Product Change Notification

Product Change Notification: PCN-23-166385

RIGHT ANGLE HEADER ASSY, TIN, GOLD15, GOLD30 SMT CONTACTS W/ THRU HOLE AND SMT HOLDDOWNS.

We would like to enjoy the opportunity to do some improvements in the customer drawings in order to make them clearer and with more and better information. (Marked Copies available)

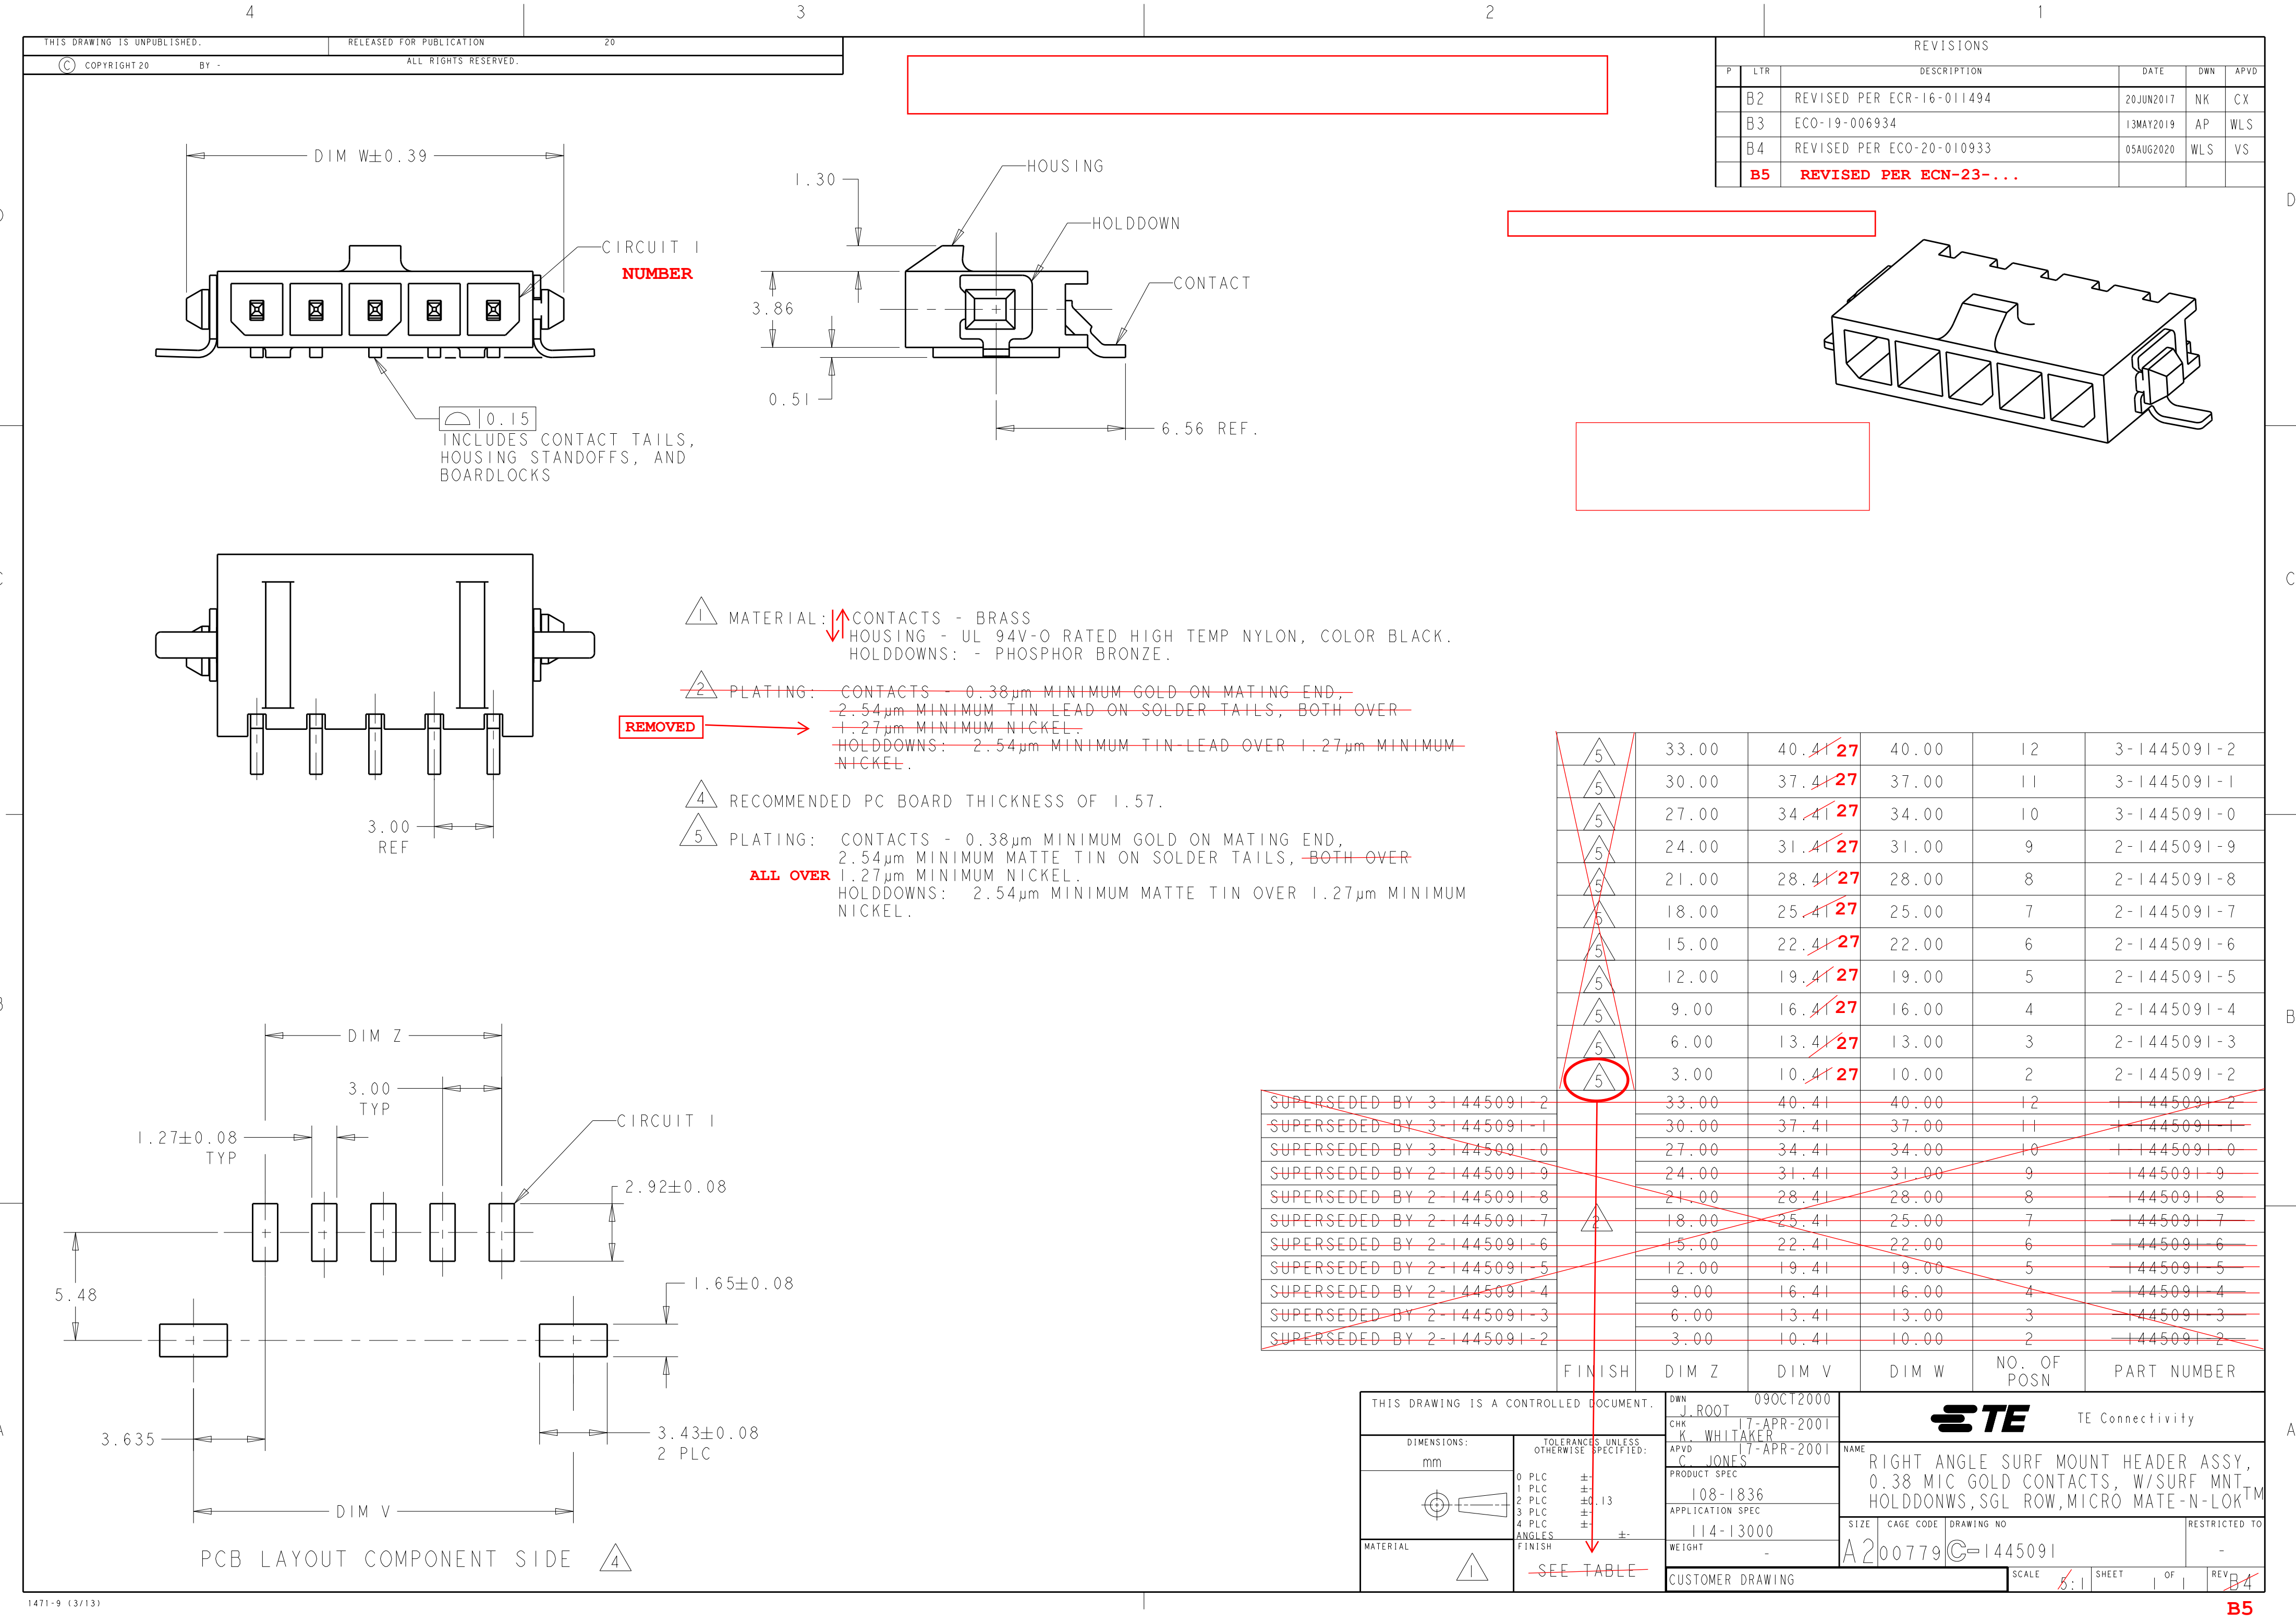
REMOVED

- 1 MATERIAL: CONTACTS - BRASS
HOUSING - UL 94V-0 RATED HIGH TEMP NYLON, COLOR BLACK.
HOLDDOWNS: - PHOSPHOR BRONZE.
- 2 PLATING: CONTACTS - 0.38µm MINIMUM GOLD ON MATING END,
2.54µm MINIMUM TIN LEAD ON SOLDER TAILS, BOTH OVER
1.27µm MINIMUM NICKEL.
HOLDDOWNS: 2.54µm MINIMUM TIN LEAD OVER 1.27µm MINIMUM
NICKEL.
- 4 RECOMMENDED PC BOARD THICKNESS OF 1.57.
- 5 PLATING: CONTACTS - 0.38µm MINIMUM GOLD ON MATING END,
2.54µm MINIMUM MATTE TIN ON SOLDER TAILS, BOTH OVER
1.27µm MINIMUM NICKEL.
HOLDDOWNS: 2.54µm MINIMUM MATTE TIN OVER 1.27µm MINIMUM
NICKEL.

ALL OVER

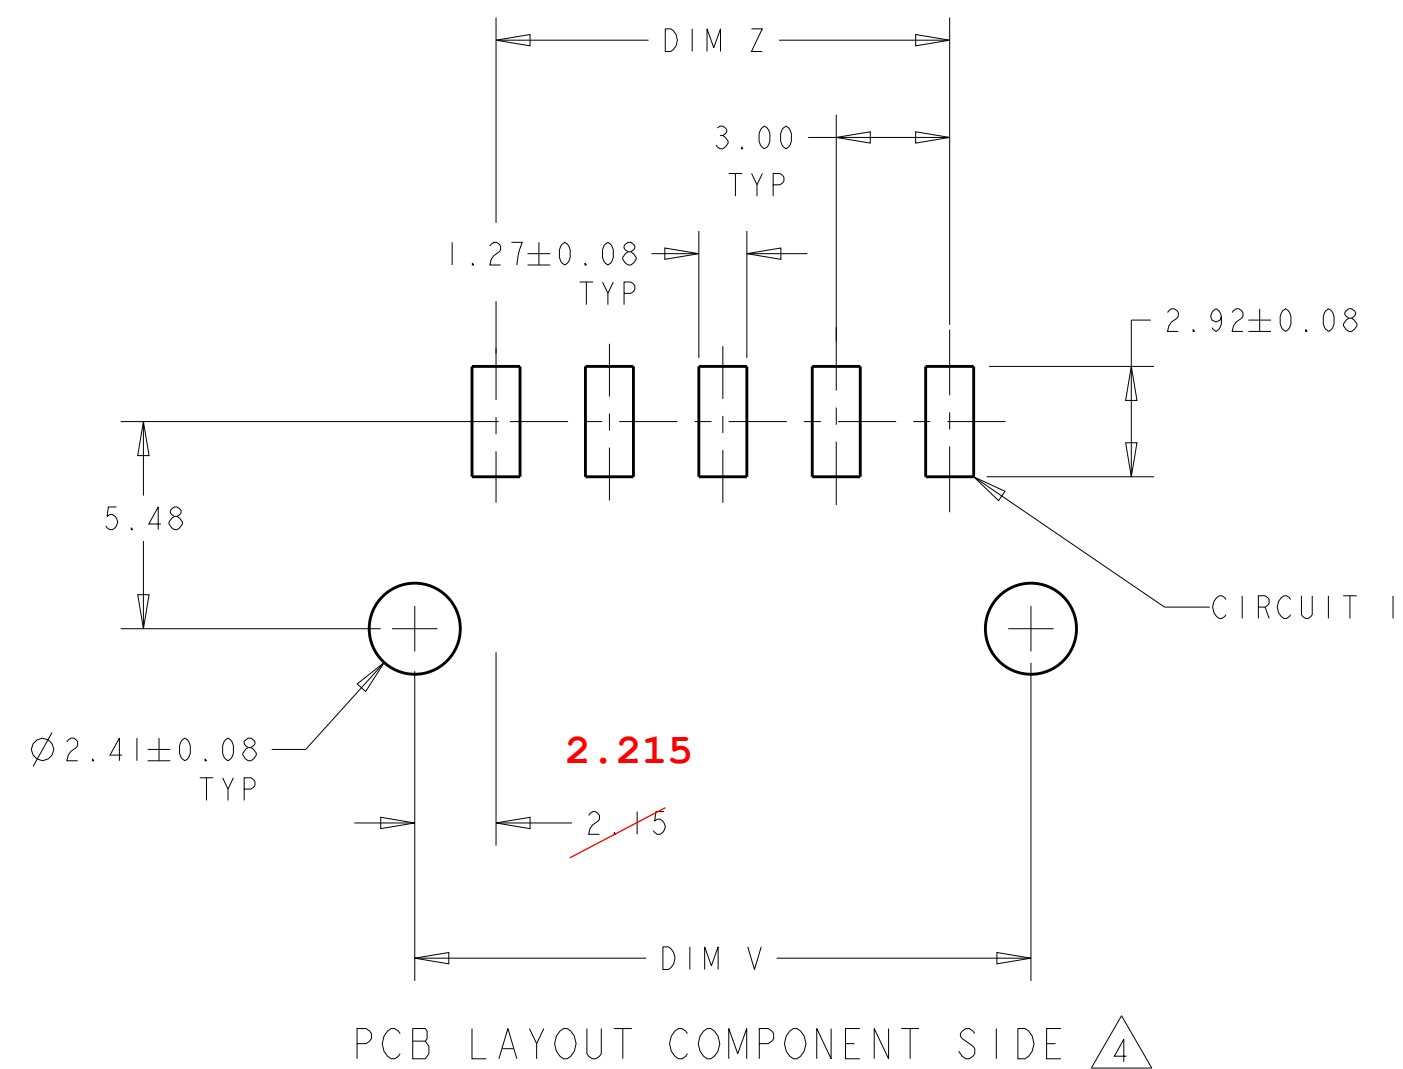
PLATING: ~~CONTACTS: 0.38µm MINIMUM GOLD ON MATING END,~~
~~2.54µm MINIMUM TIN LEAD ON SOLDER TAILS, BOTH OVER~~
~~1.27µm MINIMUM NICKEL.~~
 ~~HOLDDOWNS: 2.54µm MINIMUM TIN-LEAD OVER 1.27µm MINIMUM~~
~~NICKEL.~~

5 PLATING: CONTACTS - 0.38 μ m MINIMUM GOLD ON MATING END,
2.54 μ m MINIMUM MATTE TIN ON SOLDER TAILS, ~~BOTH OVER~~
ALL OVER 1.27 μ m MINIMUM NICKEL.
HOLD DOWNS: 2.54 μ m MINIMUM MATTE TIN OVER 1.27 μ m MINIMUM
NICKEL.

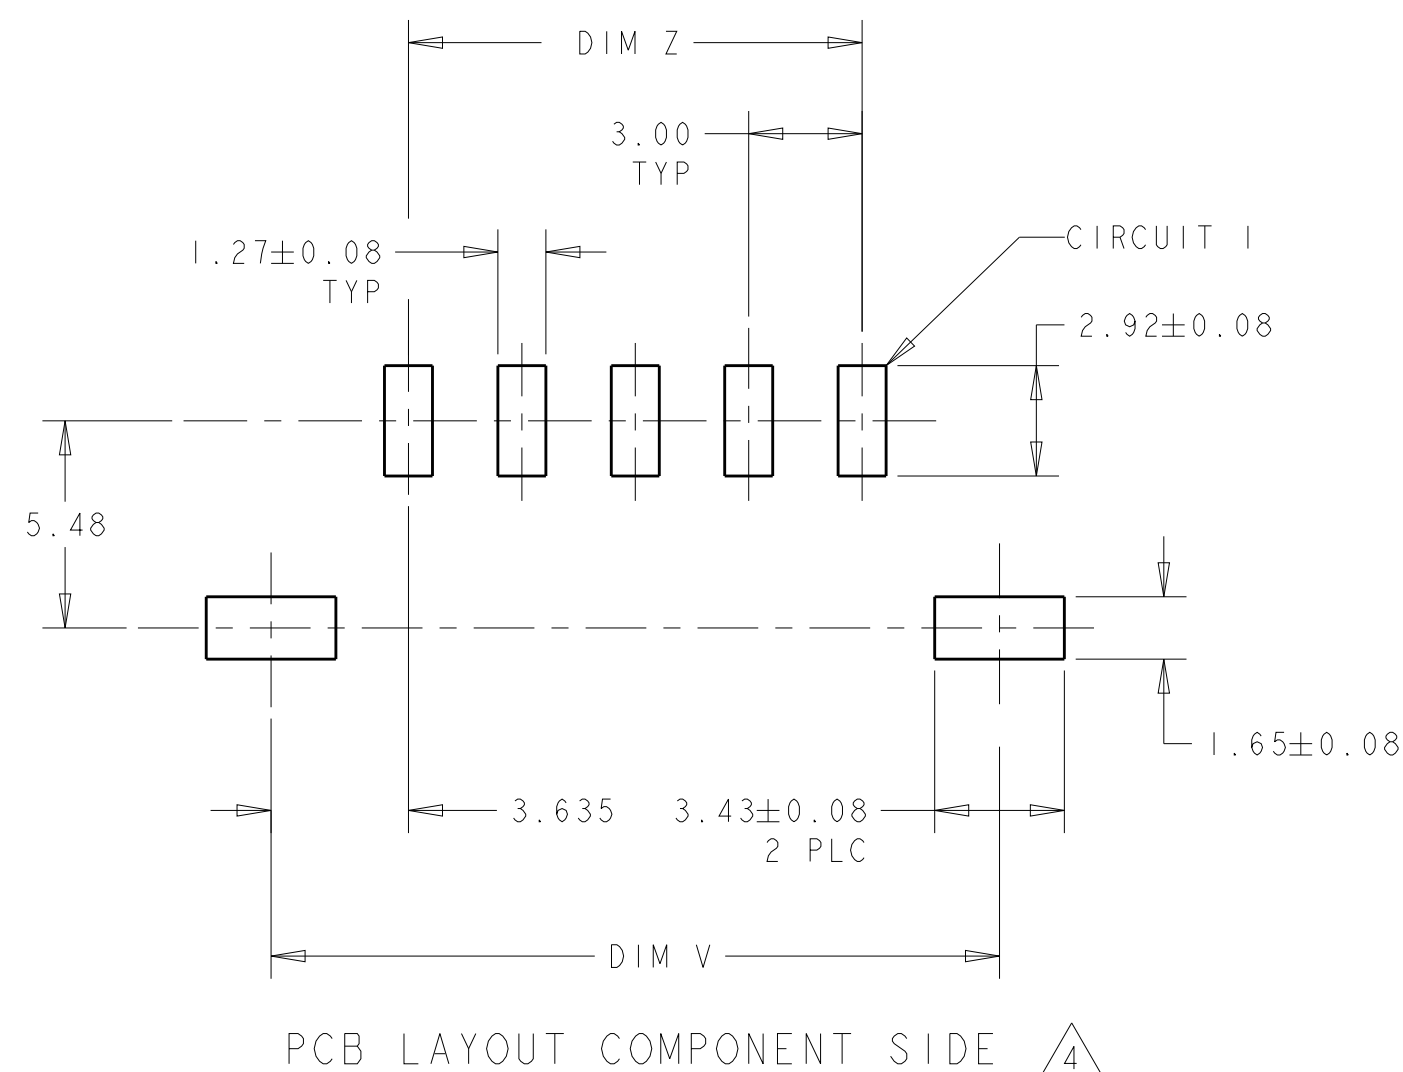
REORDERED NOTES NUMBER IF NECESSARY!

- 1 MATERIAL: CONTACTS - BRASS
HOUSING - UL 94V-0 RATED HIGH TEMP NYLON, COLOR BLACK.
HOLDDOWNS: - PHOSPHOR BRONZE.
- 2 ~~PLATING: CONTACTS - 2.54 μ m MINIMUM TIN LEAD OVER 1.27 μ m MINIMUM NICKEL.~~
~~HOLDDOWNS - 2.54 μ m MINIMUM TIN LEAD OVER 1.27 μ m MINIMUM NICKEL.~~
- 4 RECOMMENDED PC BOARD THICKNESS OF 1.57.
- 5 PLATING: CONTACTS-2.54 μ m MINIMUM TIN OVER 1.27 μ m MINIMUM NICKEL.
HOLDDOWNS- 2.54 μ m MINIMUM TIN OVER 1.27 μ m MINIMUM NICKEL.

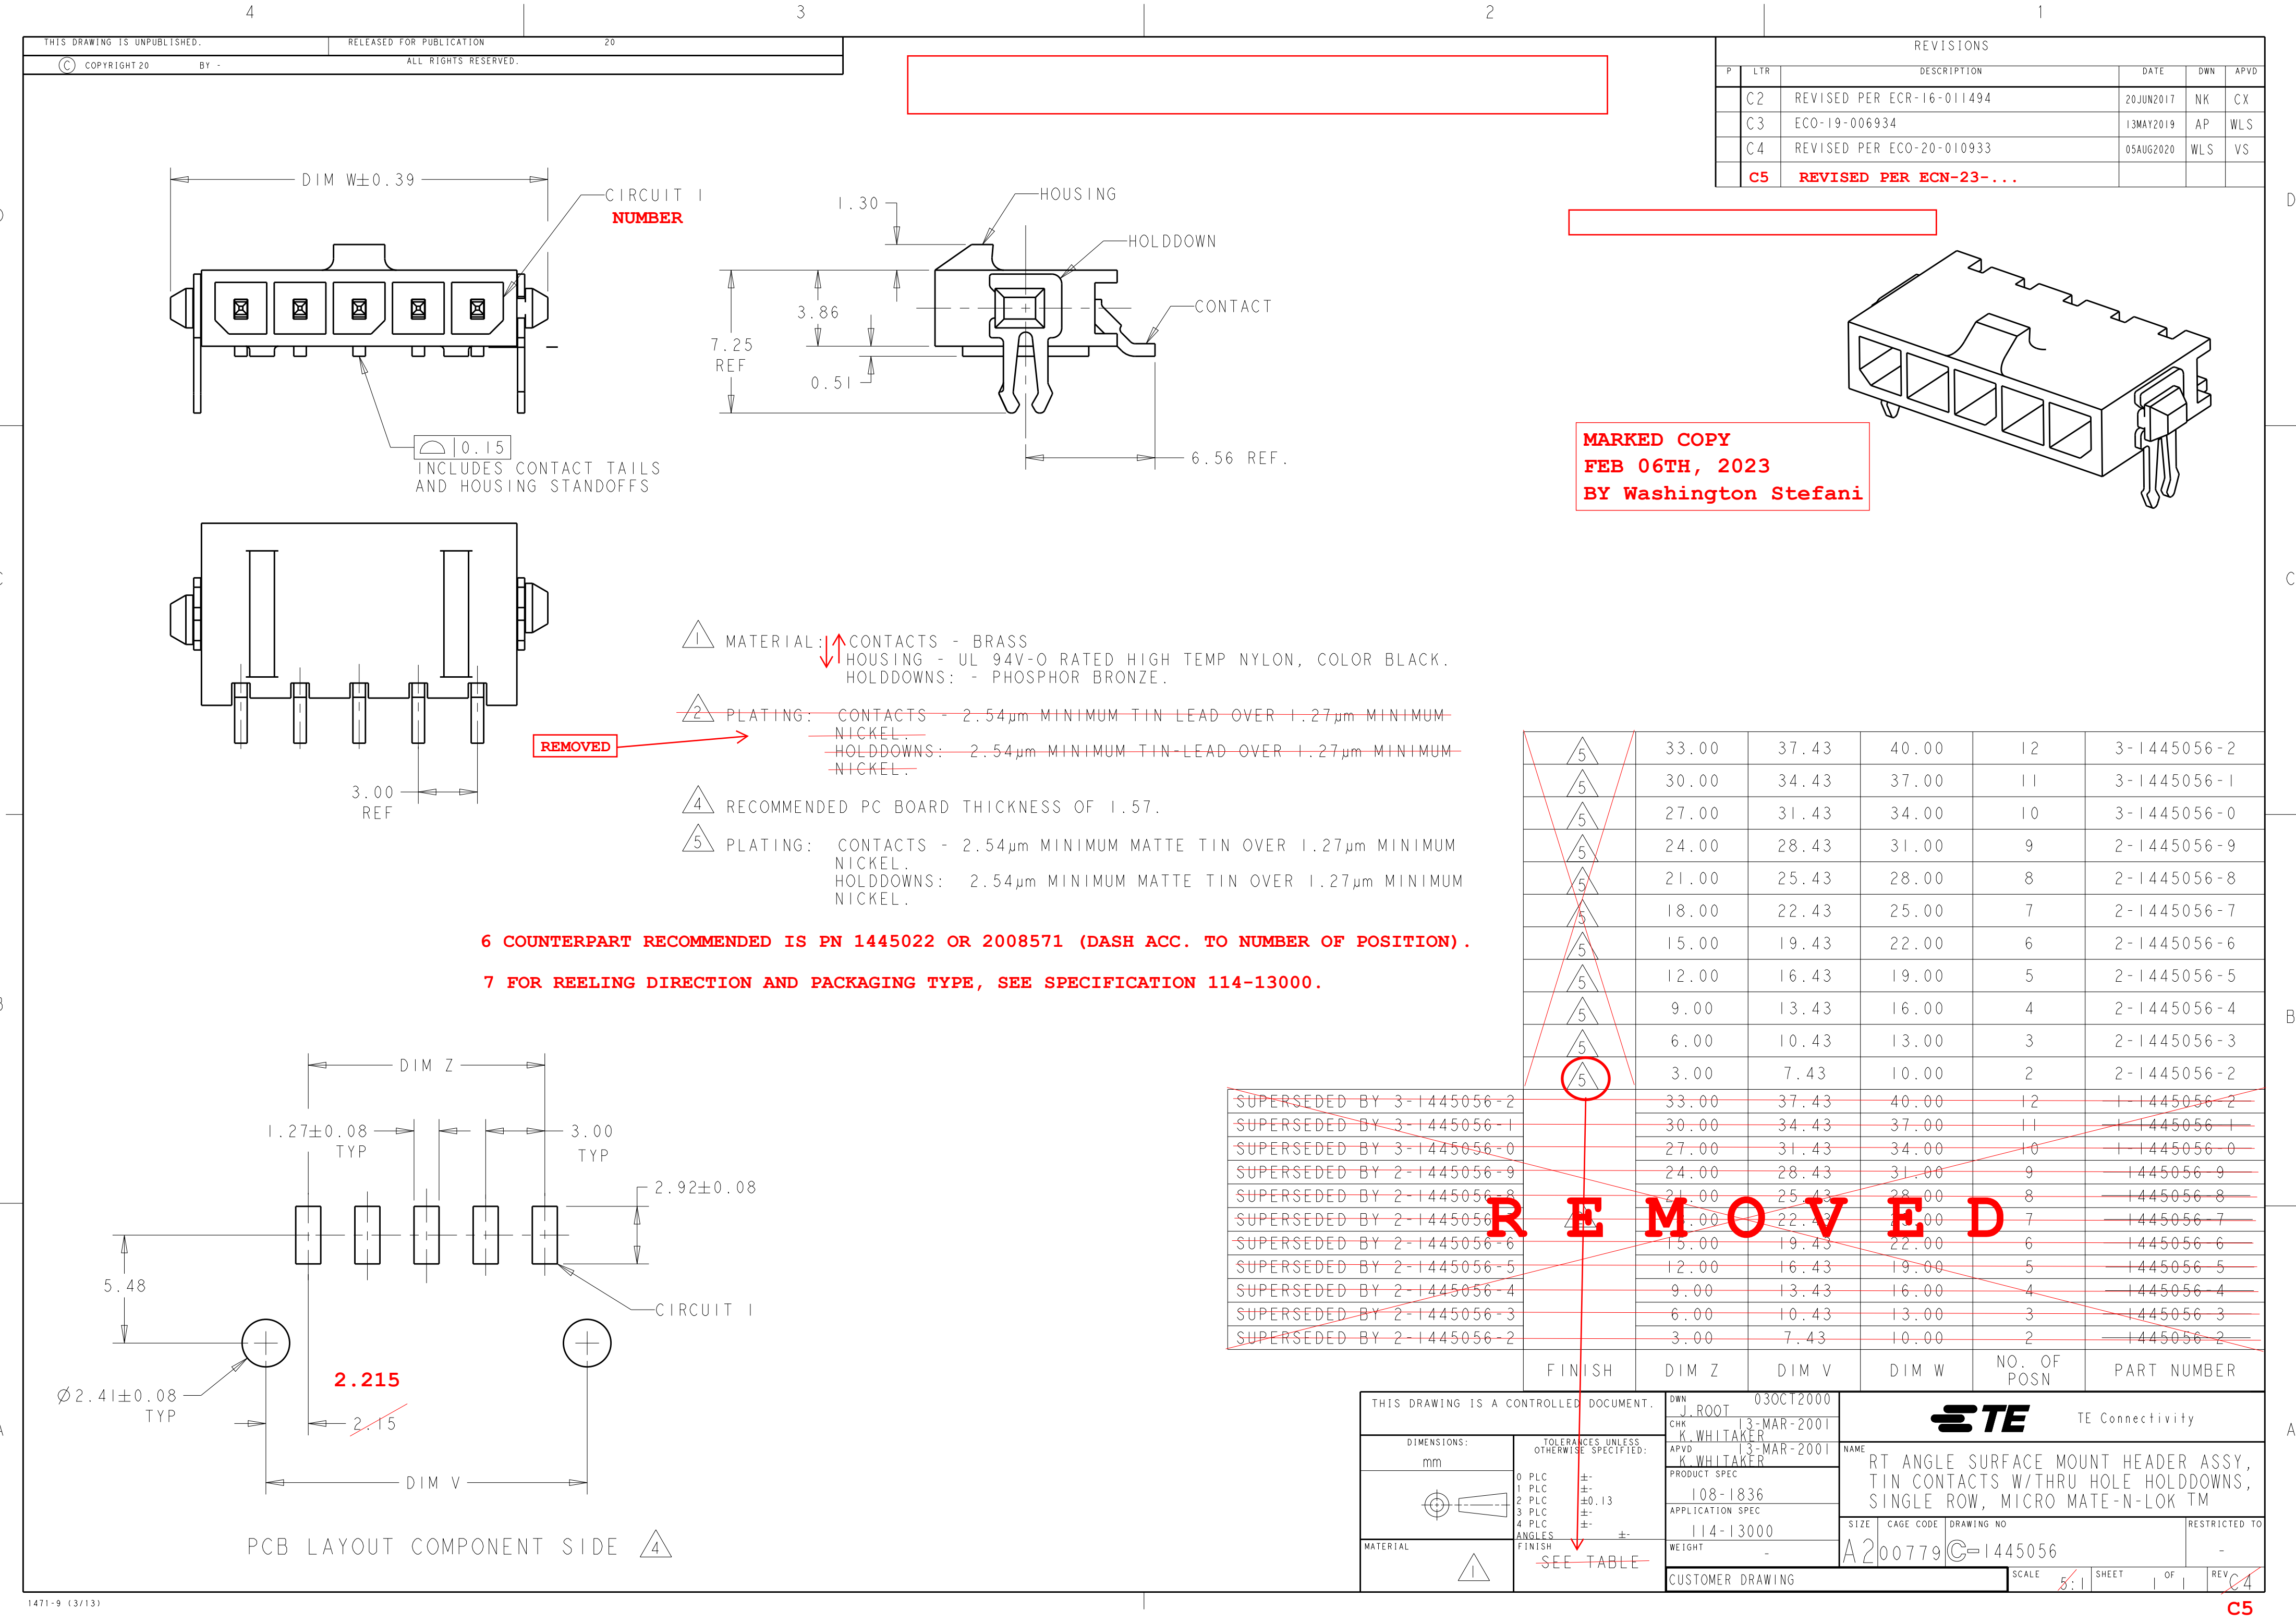
REMOVED
